1.0 MORE AIRWORTHINESS 'AGGRO'

R. B. Stratton.
Chief Technical Officer.

Airworthiness Directive

LTA-No. 75-168 Glasflügel Affected sailplane models:

201-20
Nr. 205-6, 206-1
301-30

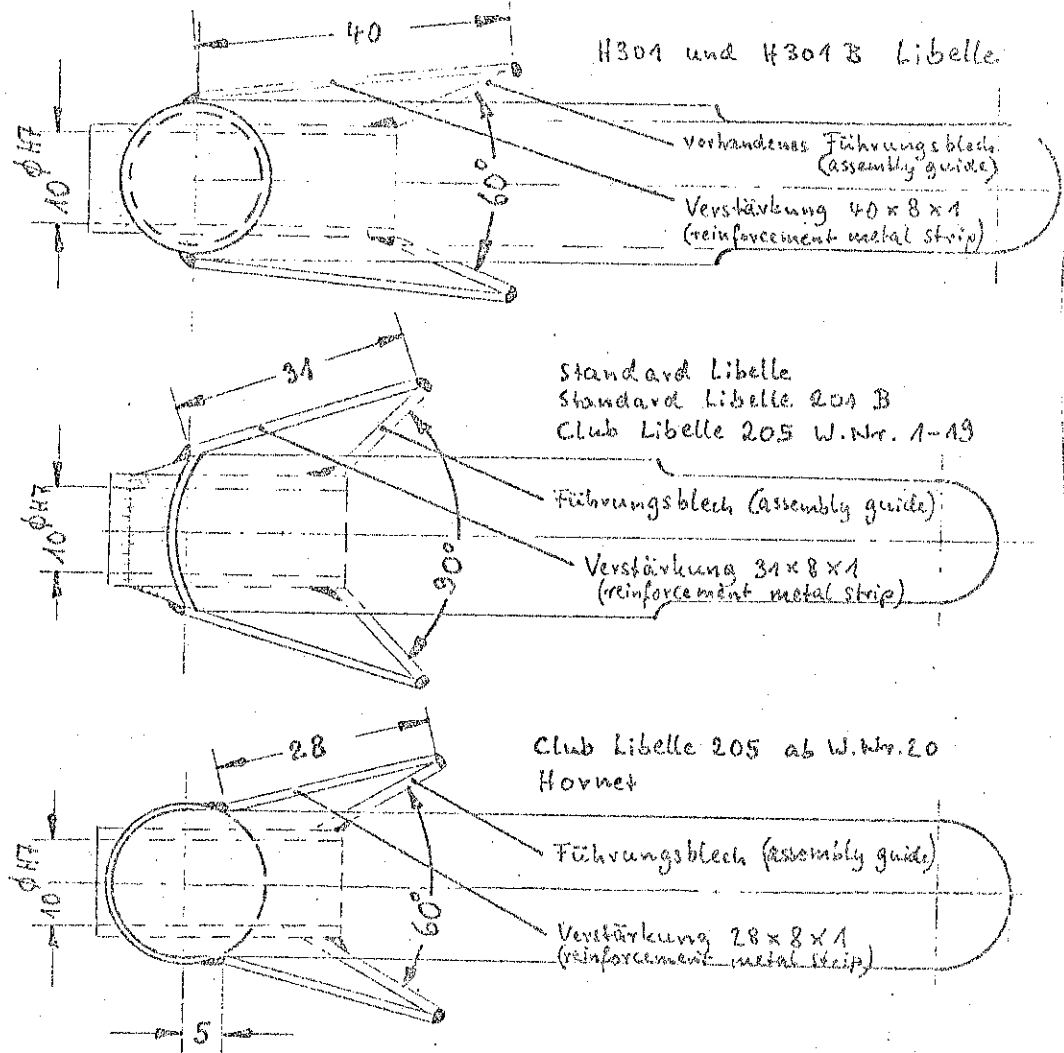
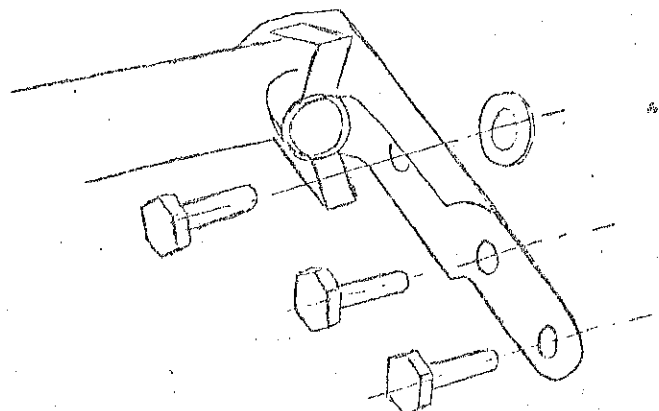
Subject: Reinforcement of the elevator assembly guides.

Reason: Careless assembly of the tailplane caused damaged elevator assembly guides, resulting in a possible improper assembly of the tailplane and loss of elevator control.

Method: 1. With a 5 x powered magnifier visually inspect the assembly guides for distortion, bending and/or for cracks in the welded seam.
 2. If damage is found replace the bracket immediately with a bracket to be reinforced according to method 4.
 3. If no damage is found replace the bracket with a bracket to be reinforced according to method 4 before the date quoted in "Urgency".
 4. Weld in two sheet metal strips according to the following drawings to reinforce both guides. (see next page)

Sheet metal to specification 1.7214.4 or 1.7734.4, welding material to specification 1.7734.2 or 1.7324.0, welding process WIG (Wolfram-Inert-Gas). After removing the bracket insert a pin 10 mm ϕ into the tube instead of the actuator pin to prevent warping during welding. It should be possible to insert this pin simply by hand. Remove the pin after the bracket has cooled down. Preserve the bracket again (recommended single component primer B 1742 from Lackfabrik Bäder and nitro lacquer). Fit the bracket to the tailplane and pay attention to the 2 washers between bracket and ball bearings.
